RE: Homestake Mining Company of California
– License SUA-1471
Grants Reclamation Project
Responses to NRC Request for Additional Information (RAI) dated 6/13/07

HOMESTAKE MINING COMPANY RESPONSES TO
Request for Additional Information, Homestake Mining Company,
Grants Reclamation Project
From the Nuclear Regulatory Commission

**SUBJECT: RESPONSE TO NRC REQUEST FOR ADDITIONAL
INFORMATION, COMMENT #2 REGARDING EMBANKMENT SLOPE
STABILITY OF EP3 EMBANKMENT**

Homestake Evaporation Pond Number 3: Response to NRC Request for Additional Information Comment No. 2

Figure 10. Static Analysis: Phreatic Surface 3, Corrected Janbu Method

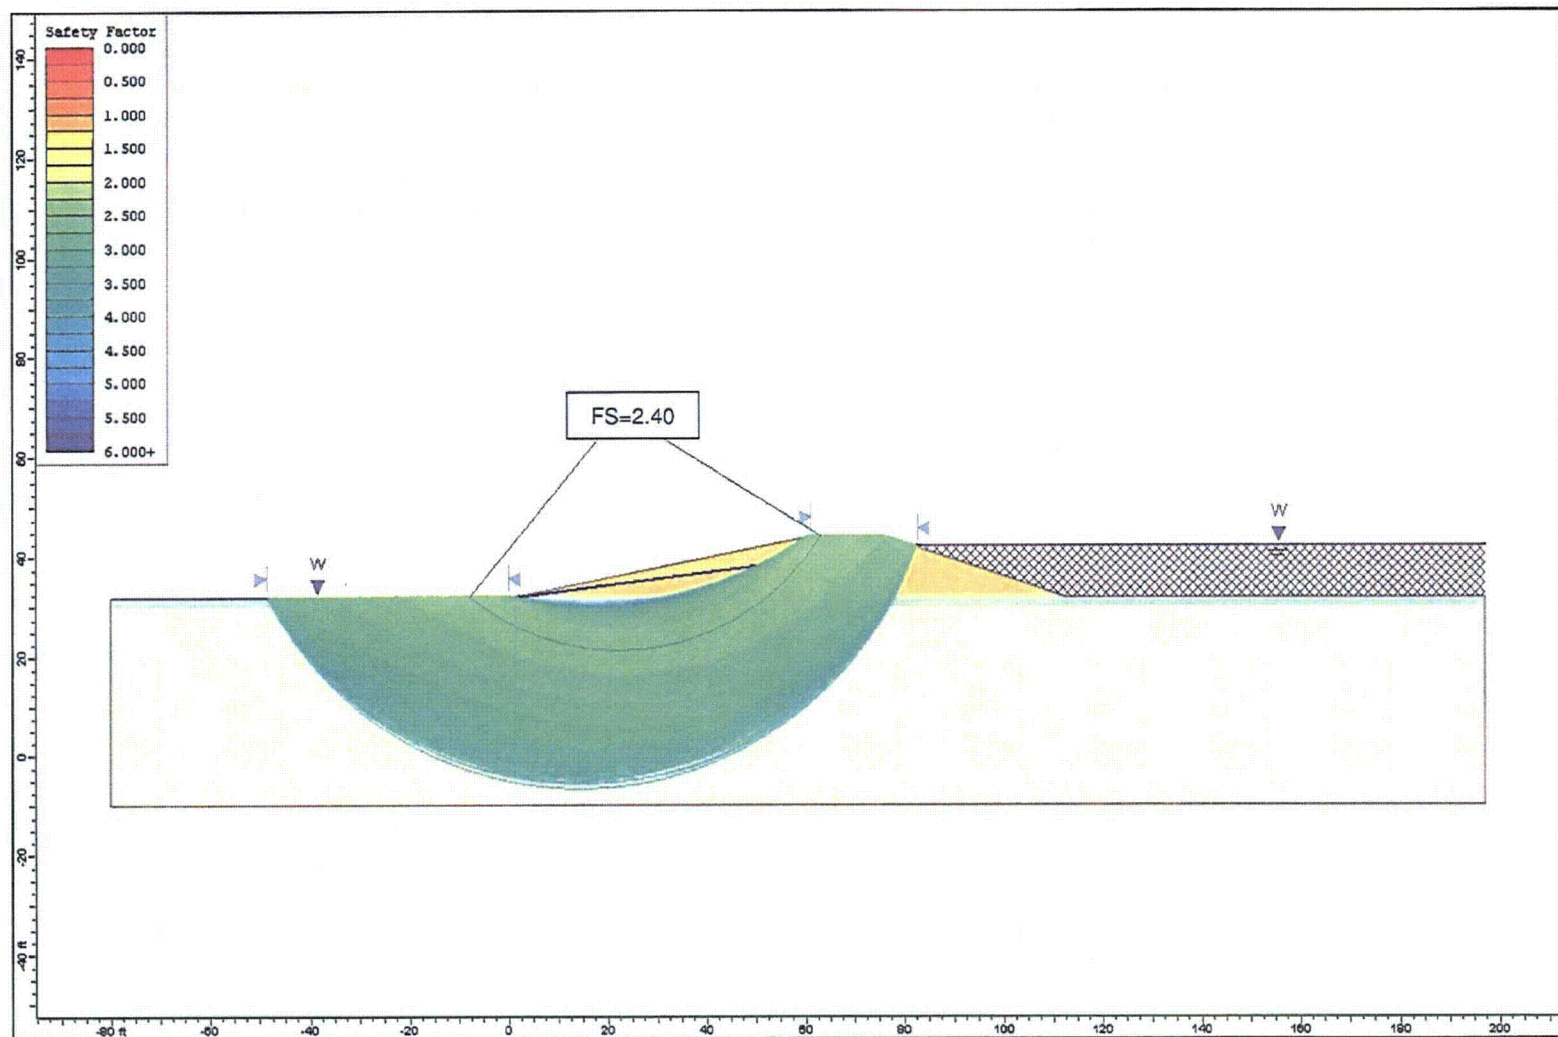
Slope stability analysis was performed using the SLIDE program (Reference 4) to determine a minimum static factor of safety for the EP3 embankment. The Simplified Bishop and corrected Janbu methods were used in the analysis, and a circular failure plane was assumed. The failure initiation limits were confined to the water surface intersection with the inslope and the outer crest of the embankment. The failure termination limits were confined to the outslope toe and 50 feet beyond the toe. These limits were assigned in order to confine the analysis to failure surfaces that would cause loss of pond water containment. Termination limits are shown in Figures 2 through 4. A total of 960 trial failure surfaces were searched within these limits.

completely saturated embankment. The second phreatic surface represents a water level equal to the maximum allowable water height, namely, a freeboard of 2 feet with saturation extending to the slope. The third scenario also represents a freeboard height of 2 feet but has the phreatic surface extending to the outslope toe. A minimum factor of safety for each scenario was determined using SLIDE. Results of the static slope stability analysis are presented in Table 2 and Figures 5 through 10 and figure 17.

The scenario where the embankment becomes fully saturated and all cohesion is lost in the clay is presented in Figure 17 and represents a complete loss of soil suction.

Figure 11. Pseudo-Static Analysis: Phreatic Surface 1, Simplified Bishop Method
 $g = 6.2\%$ (10% Probability of Exceedance in 50 Years, or 475 Year Return)

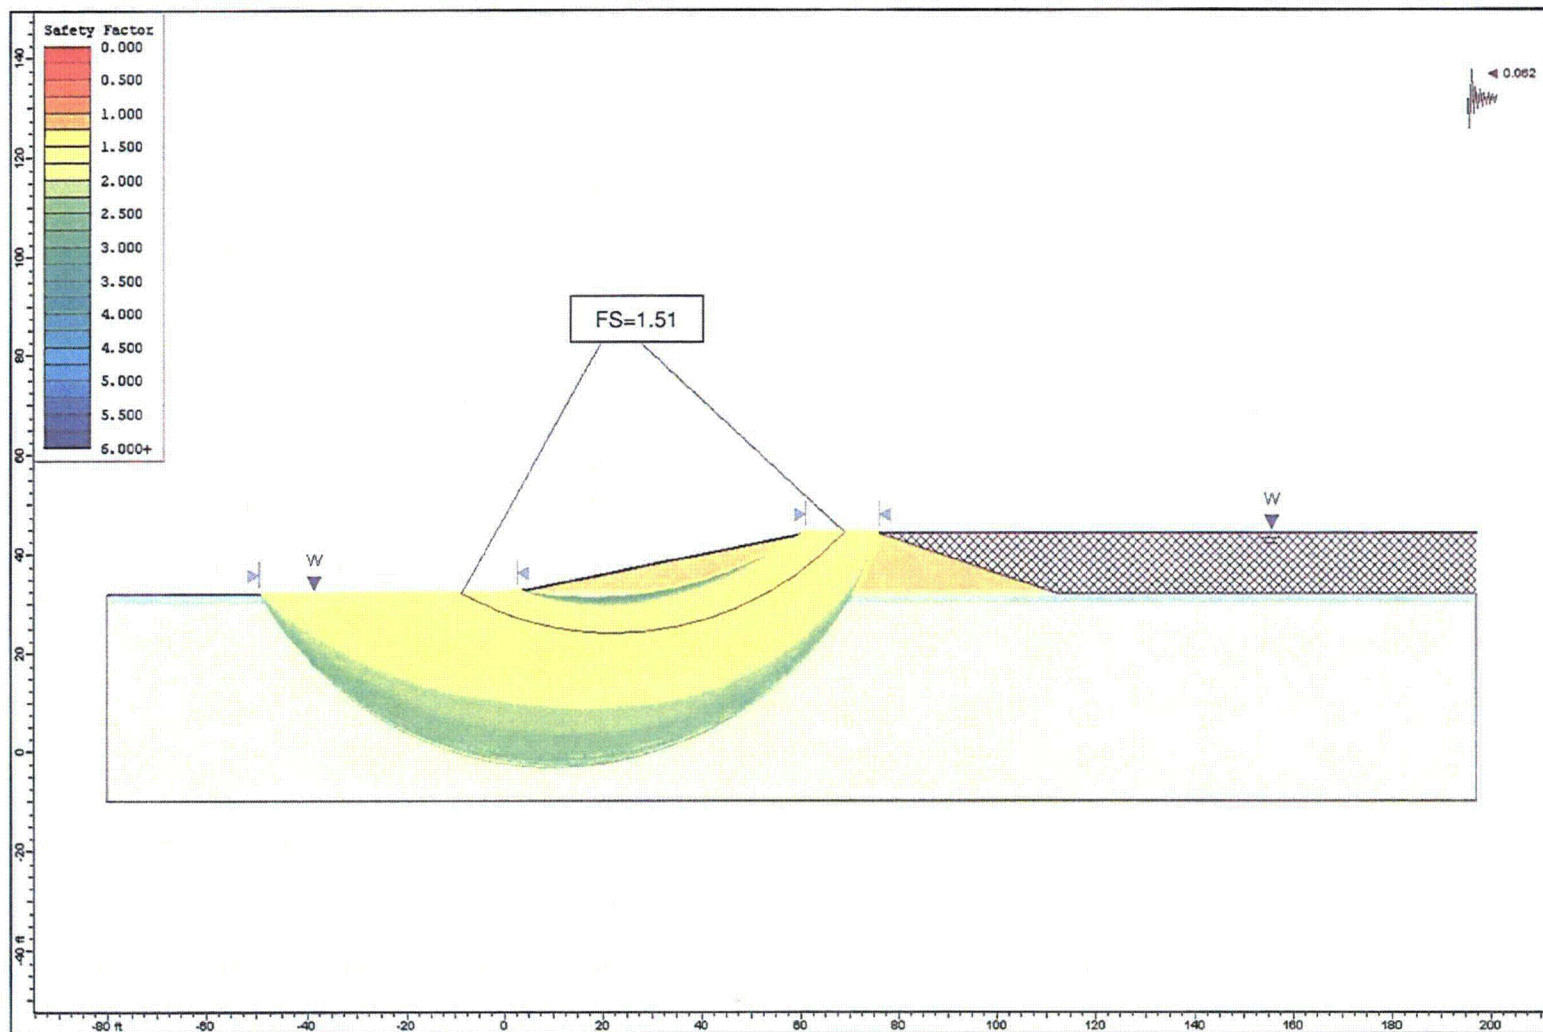
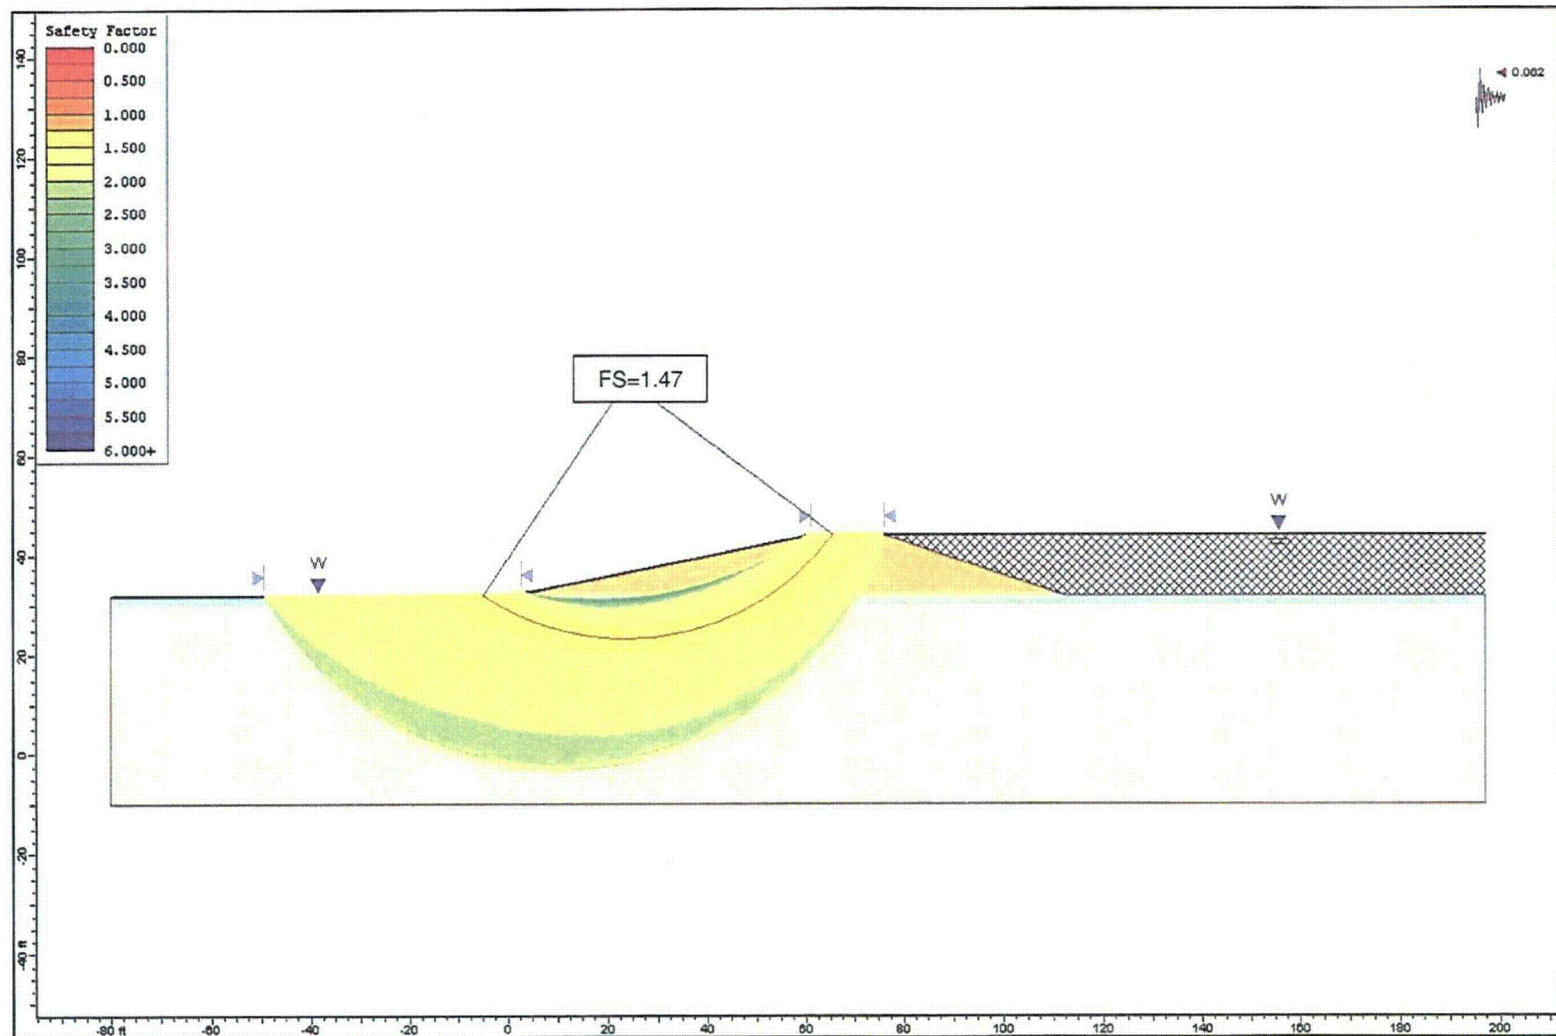
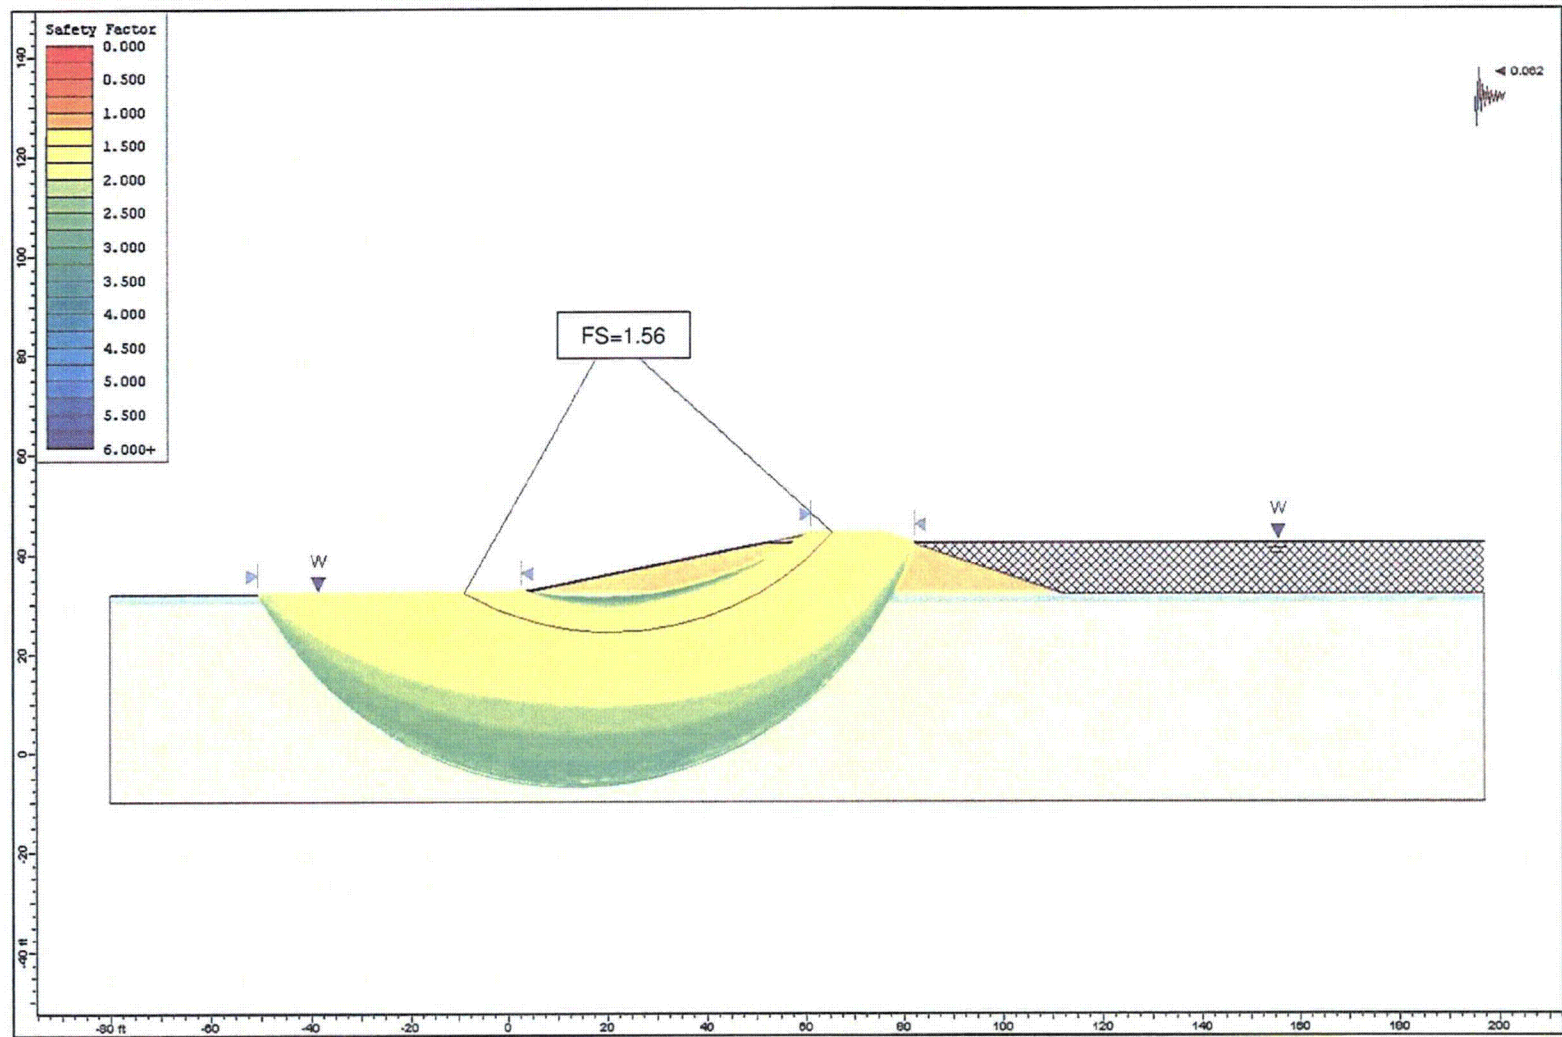
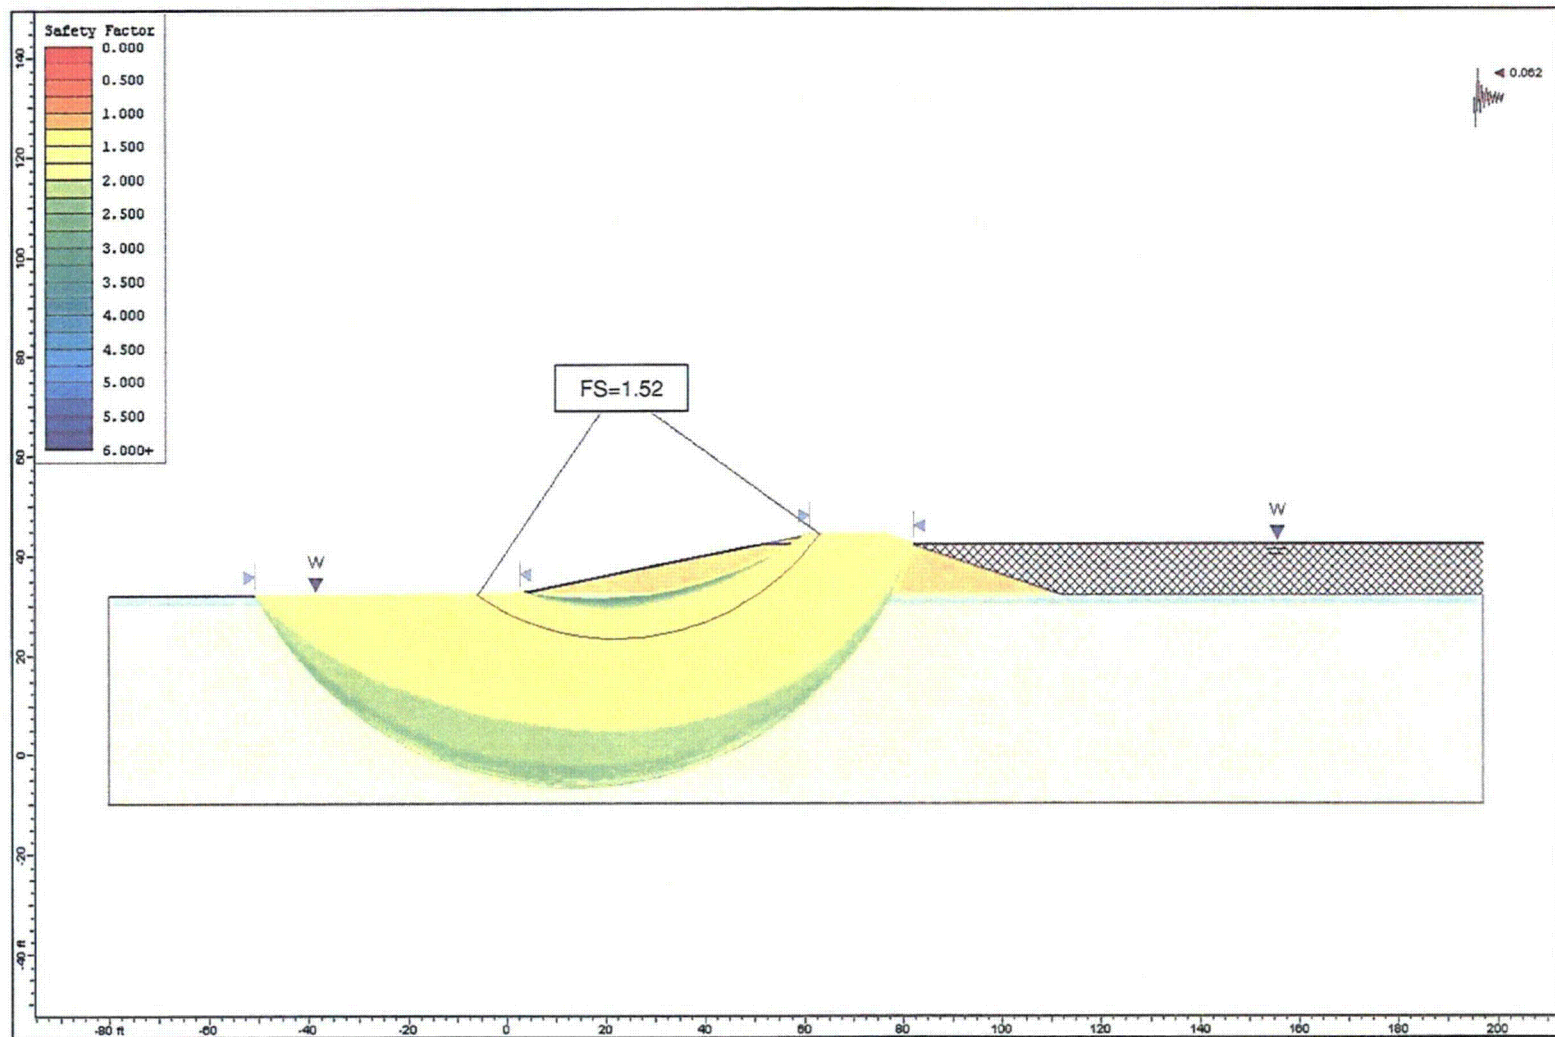
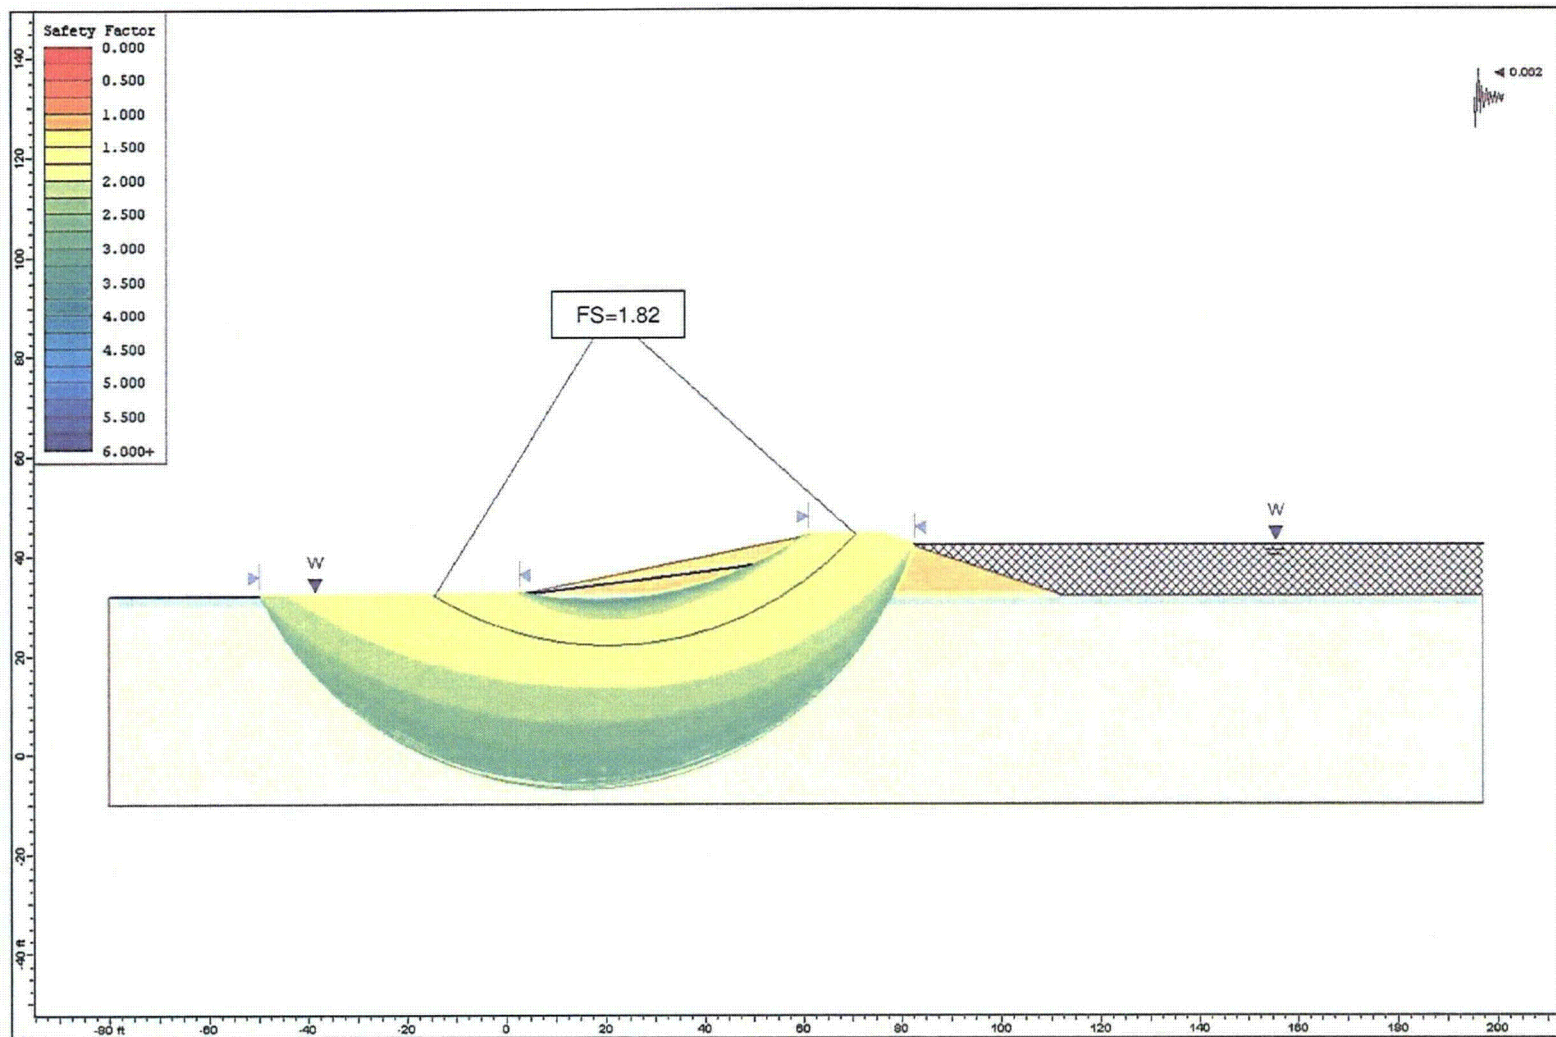
Slope stability analysis was also performed considering a seismic load applied to the EP3 embankment. This seismic load was obtained from USGS national and regional seismic hazard maps (Reference 5). A 10% probability of exceedance in 50 Years (475 Year return) peak ground acceleration value of $g = 0.062$ was used in the analysis. The three phreatic surfaces described in the previous section were added to the pseudo-static analysis, and a minimum factor of safety for each scenario was determined. Results are shown in Table 3 and Figures 11 through 18.

The minimum factor of safety of the EP3 embankment for static load conditions was 1.4 assuming completely saturated conditions (phreatic surface 1) and a complete loss of soil suction (considered to be impossible in this location). The minimum factor of safety for the pseudo-static analysis was 1.05 for fully saturated conditions where the $c \Rightarrow 0$ but the Φ would probably be between 25° and 30° . Completely saturated conditions represent the worst-case scenario for the EP3 pond. Due to the relatively high factors
